FINAL
Supplement No. 1
to the
Environmental Impact Statement
for the
Dallas Floodway Extension
Trinity River, Texas

US Army Corps
of Engineers
Fort Worth District

April 2003

FINAL
SUPPLEMENT I to the ENVIRONMENTAL IMPACT STATEMENT
DALLAS FLOODWAY EXTENSION,
TRINITY RIVER BASIN, TEXAS

FIGURE 3-1 STANDARD PROJECT FLOOD

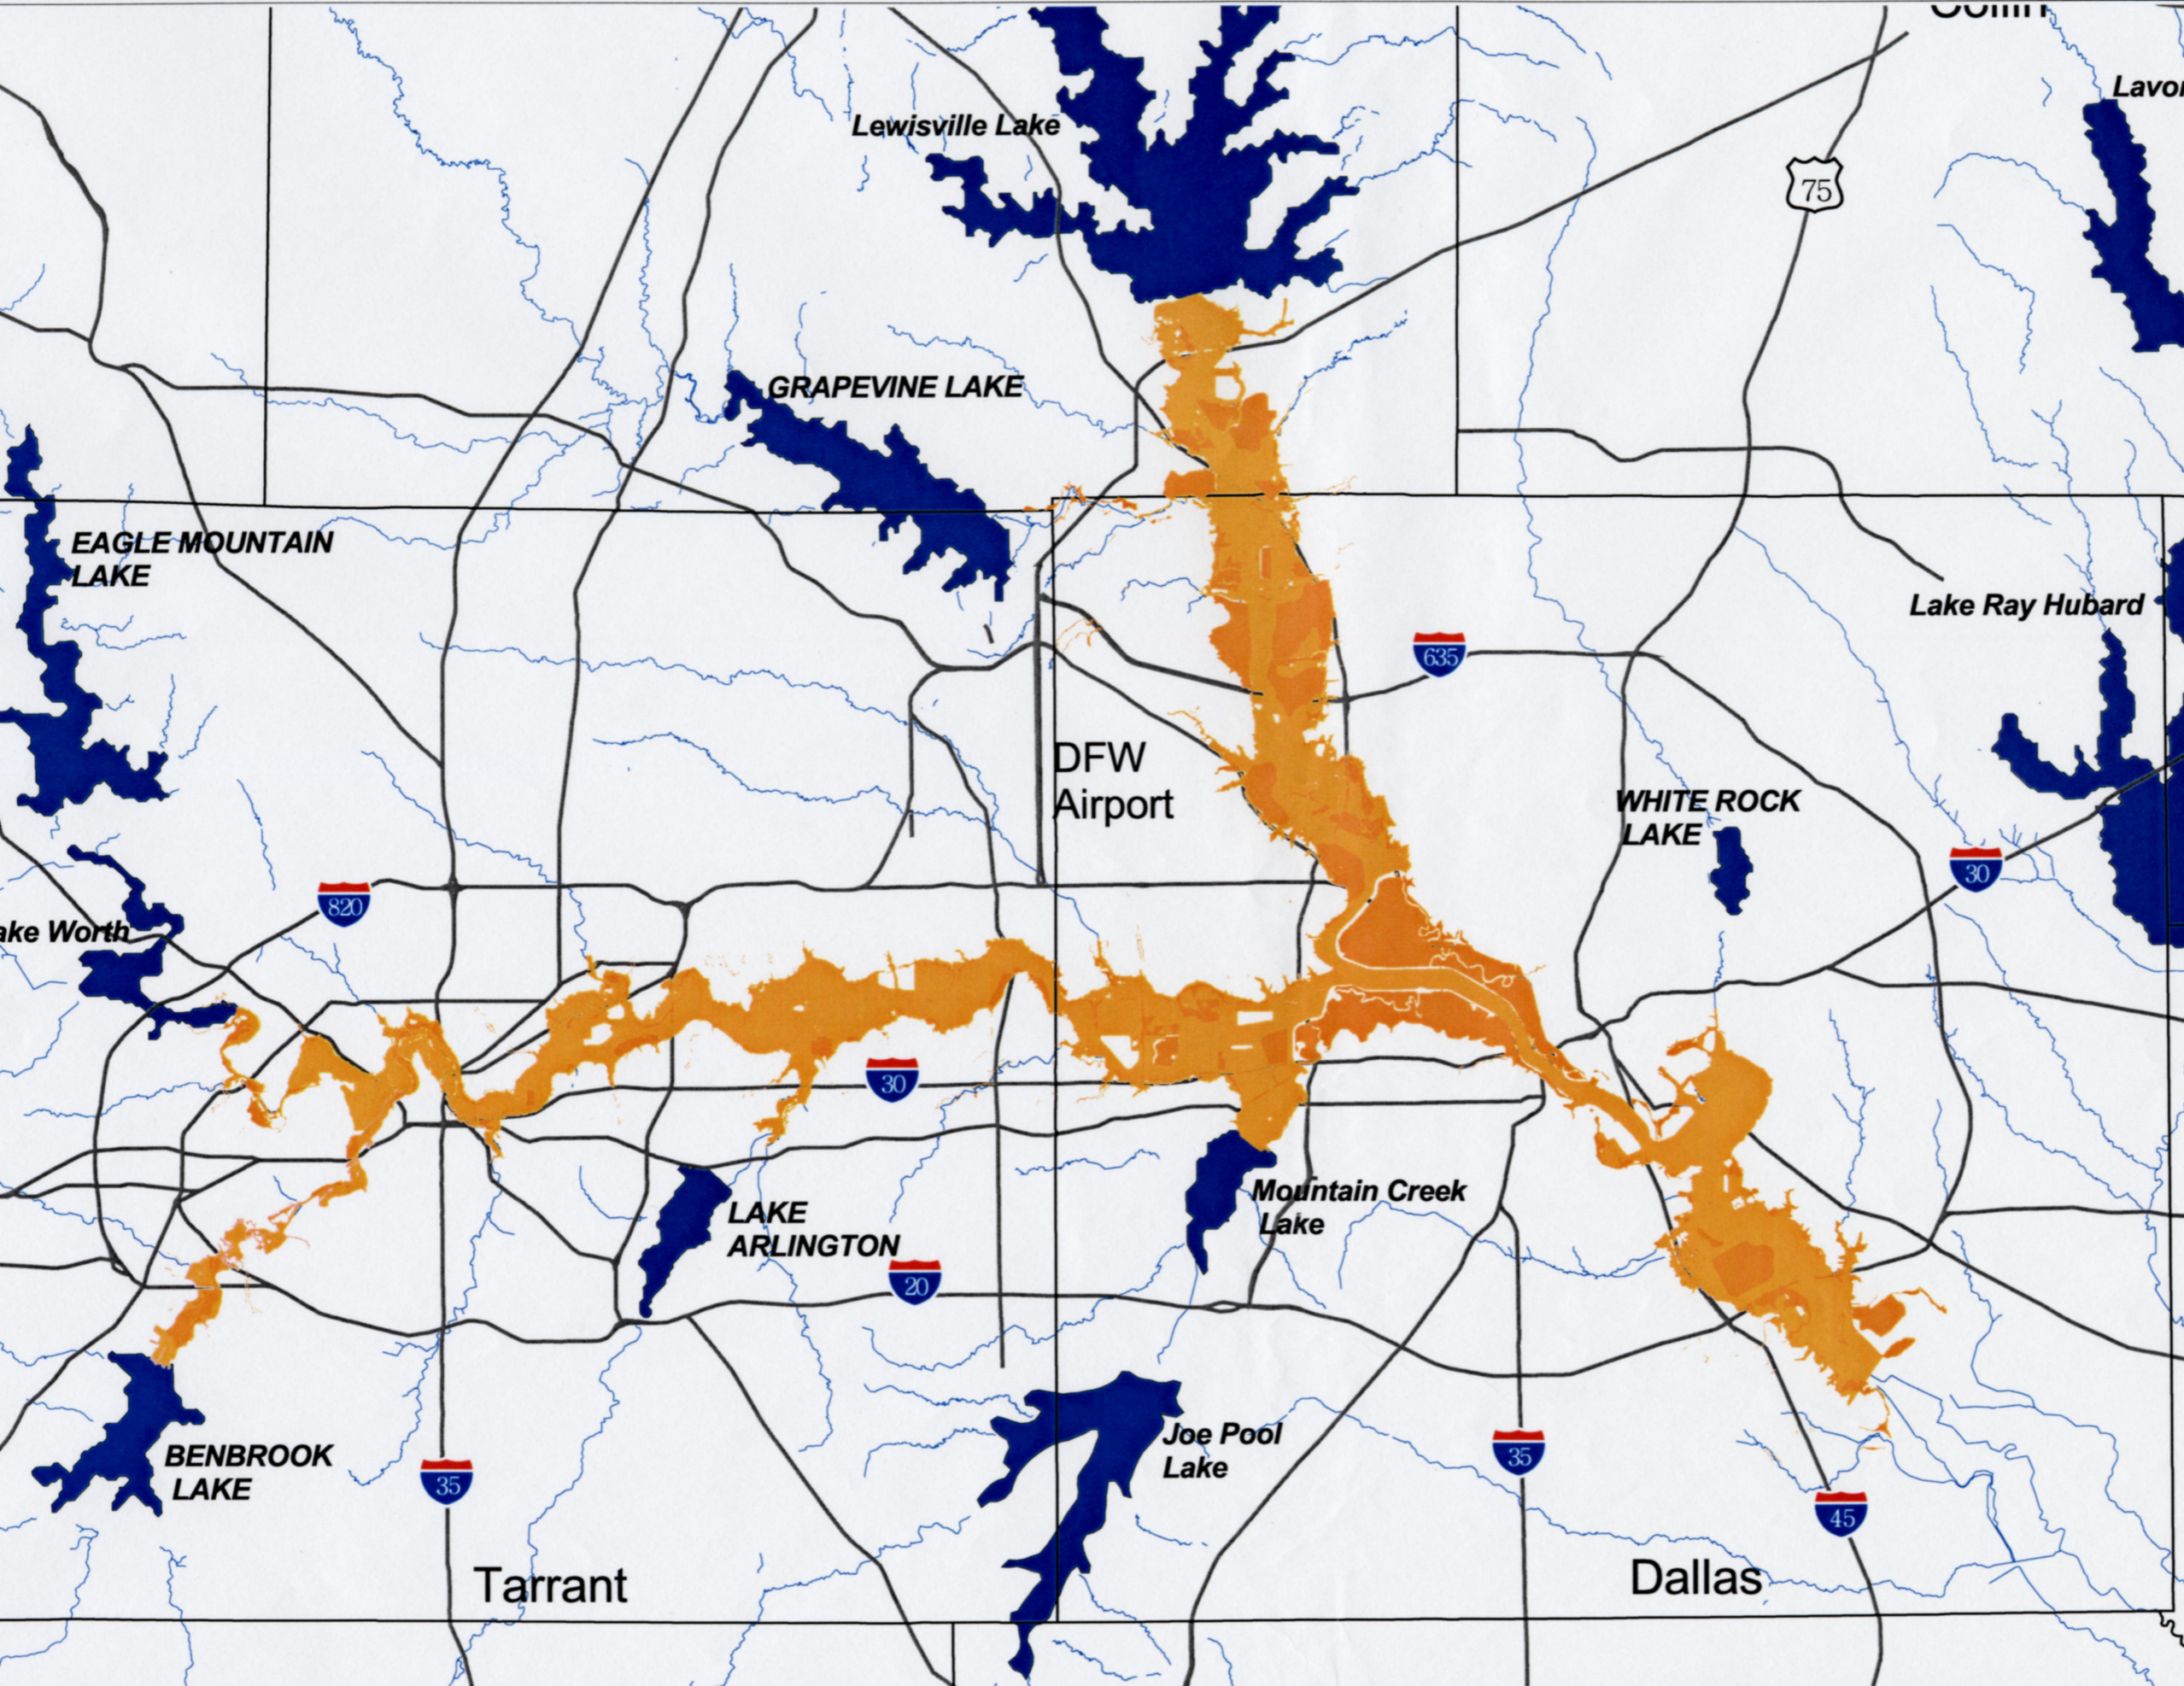
3.	Last paragraph has typographic error of "or" rather than "of".
4.	Fig 3-1 It would be helpful to show which of the highways would not be covered by a SPF under current protection. Or does it already accurately show that all highways would be flooded?

FIGURE 3-3, TRINITY RIVER CORRIDOR LAND USE PLAN (CLUP)

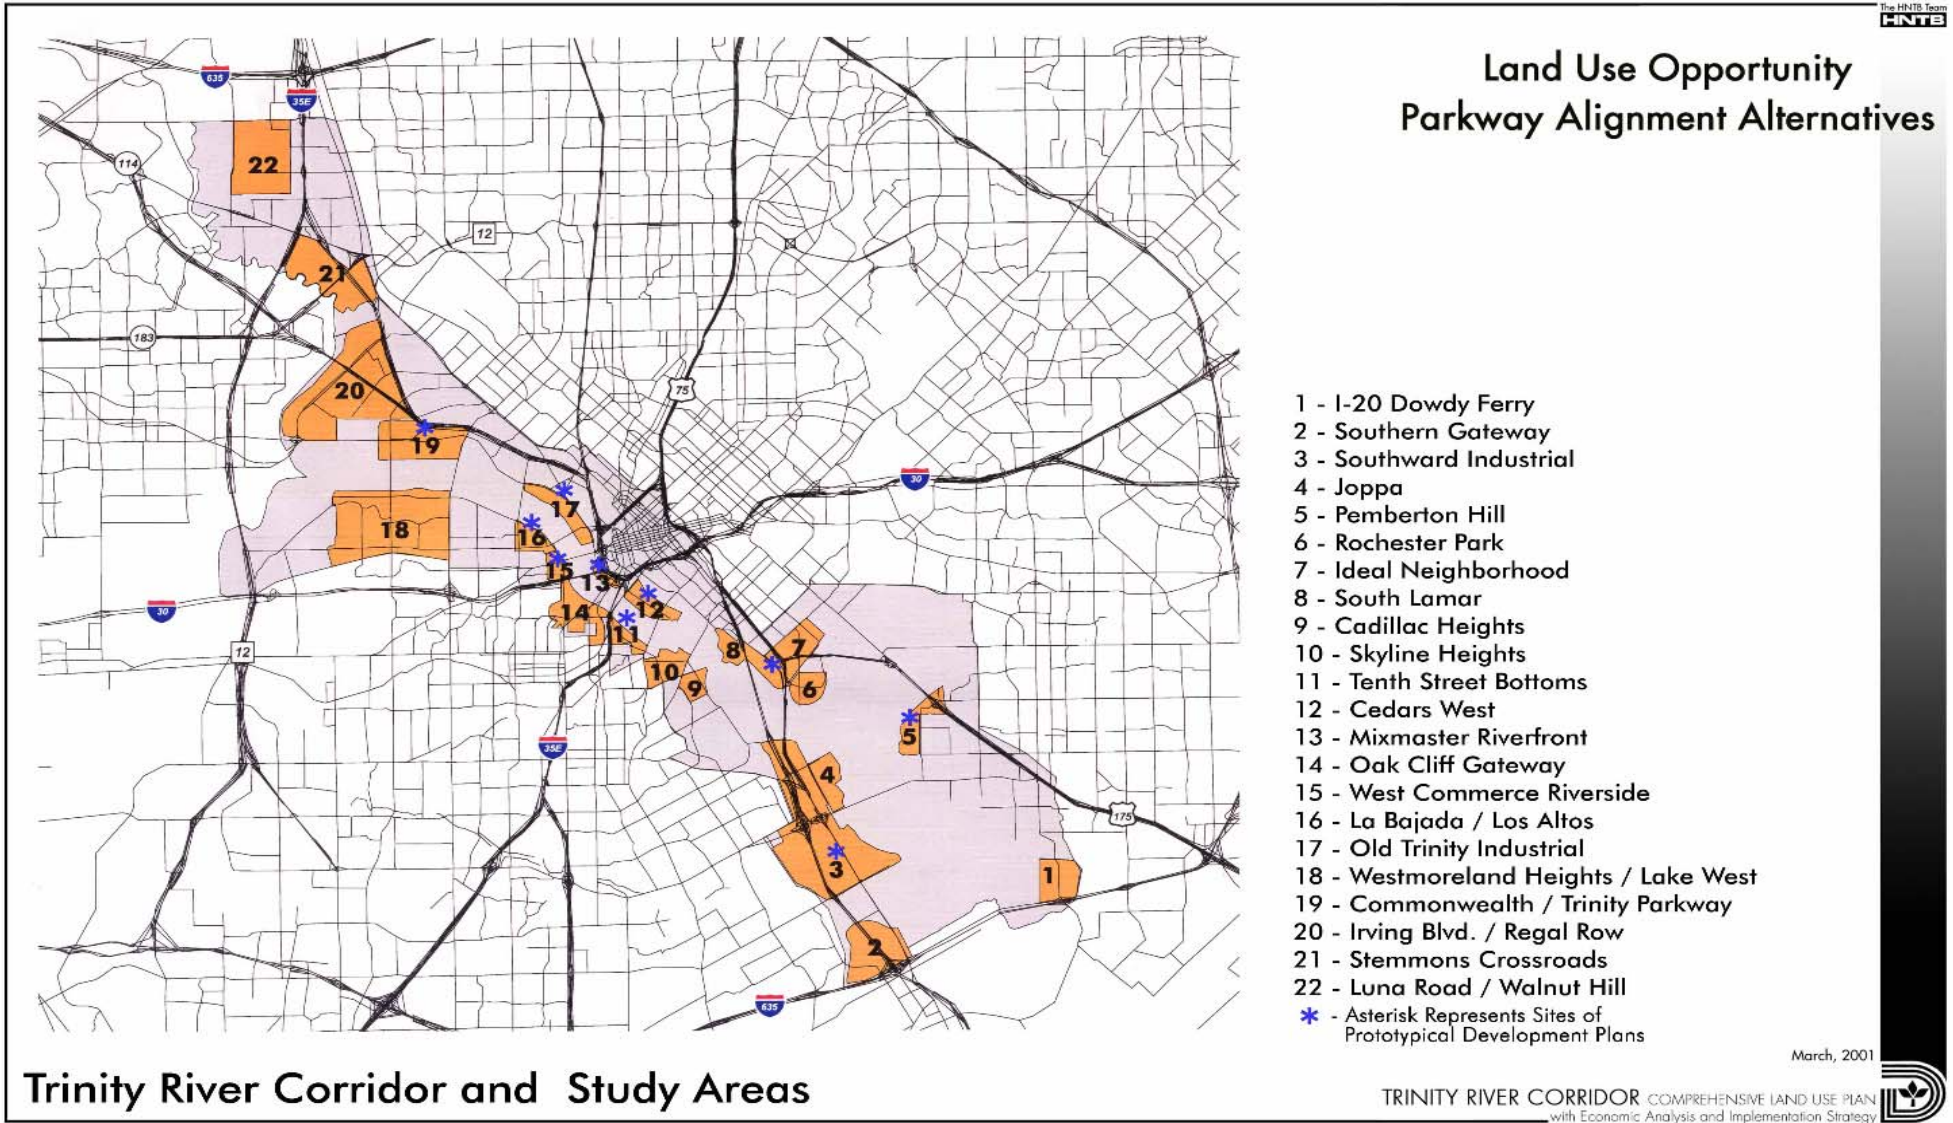
39. P. 3-17, para. 5. Figure 3-3 should be on page 3-18.

FIGURE 3-9
 Corps of Engineers
 Civil Works Projects
 and Permit Actions

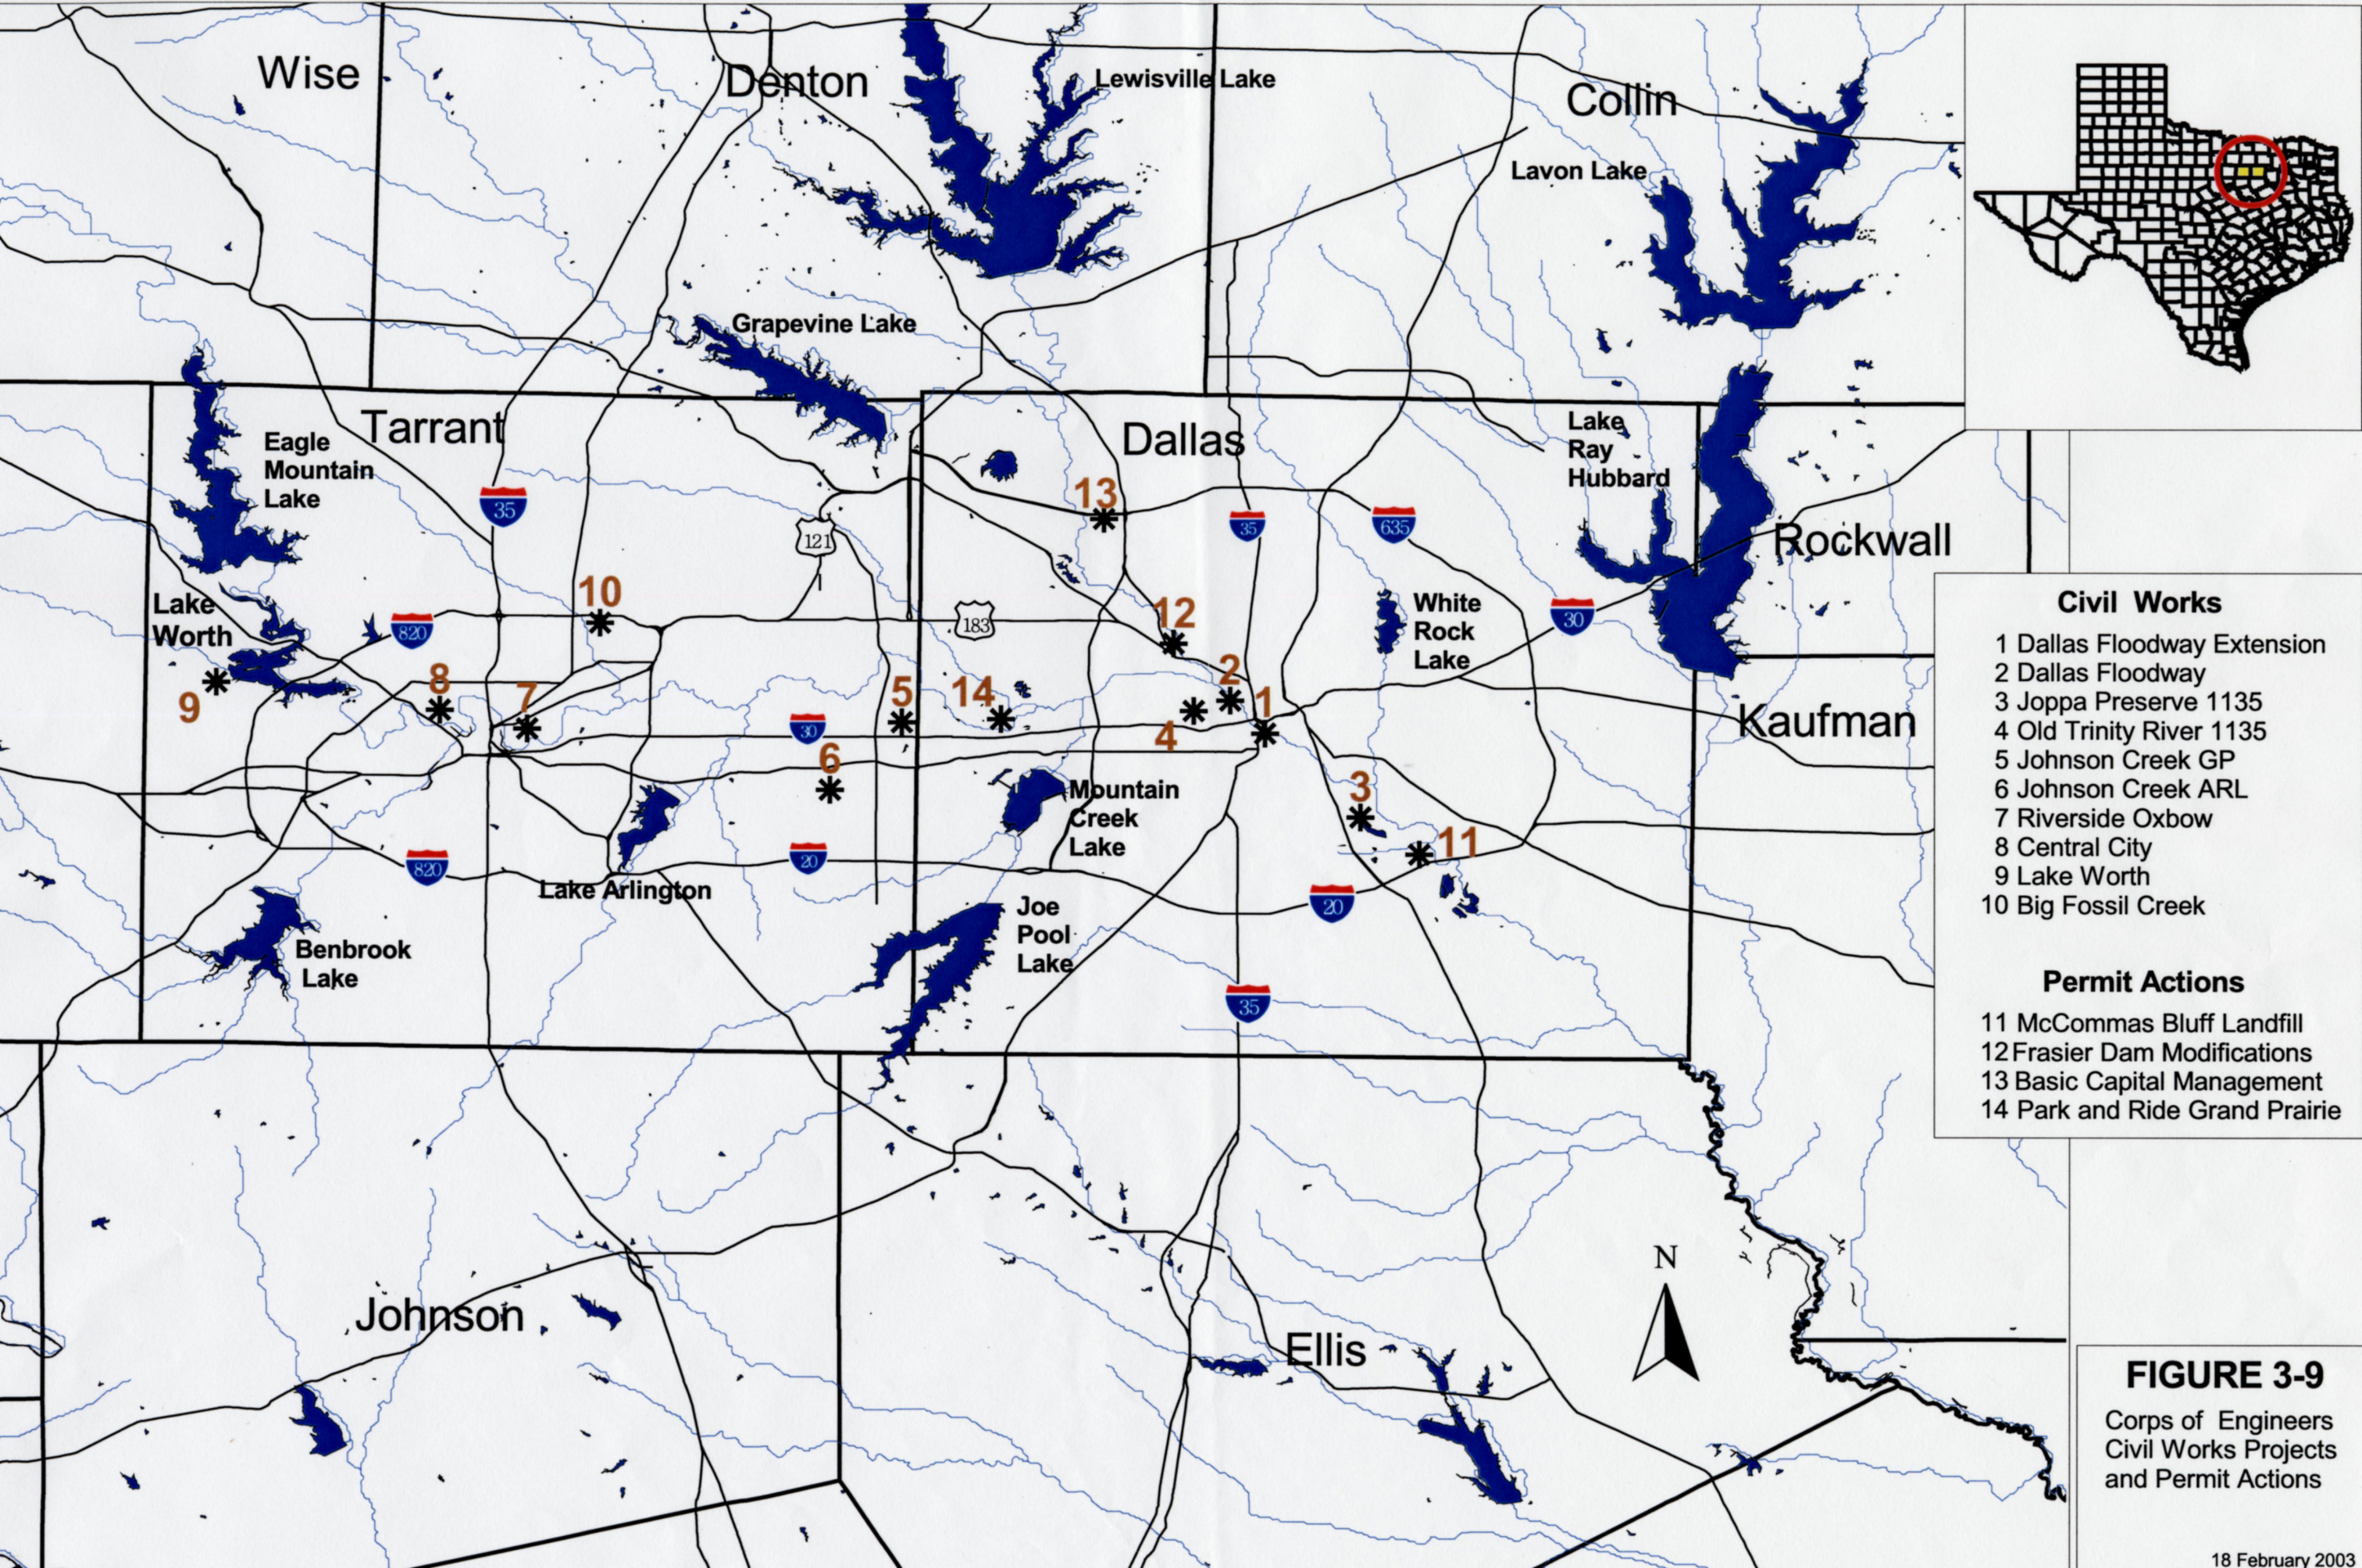
41. P. 3-34, end of chapter general comments. CESWF should have produced a map of all of the projects they describe in this chapter. CESWF produced a map, Figure 3-3 of all the CLUP possible developmental opportunities gathered in the past two years, but CESWF can not produce a map of all the projects they describe in the Trinity river corridor that they have known about for many years. CESWF should have had the agency(s) or agency project managers of each project submit to them by July 2002 a brief summary report describing the project with alternatives and specifications on a schematic map of their project (with alternatives), instead of the CESWF using 34 pages of the report describing each

64. Map included in PEIS and added to SEIS (See Figure 3-9) Extensive scoping was conducted to determine the projects proposed that might have cumulative impacts in relation to the DFE. Scoping included public meeting, public notice requesting information, newspaper notices, individual contact with agency employees and written correspondence to city representatives familiar with proposed development. The information we obtained came from these sources and from other published information.
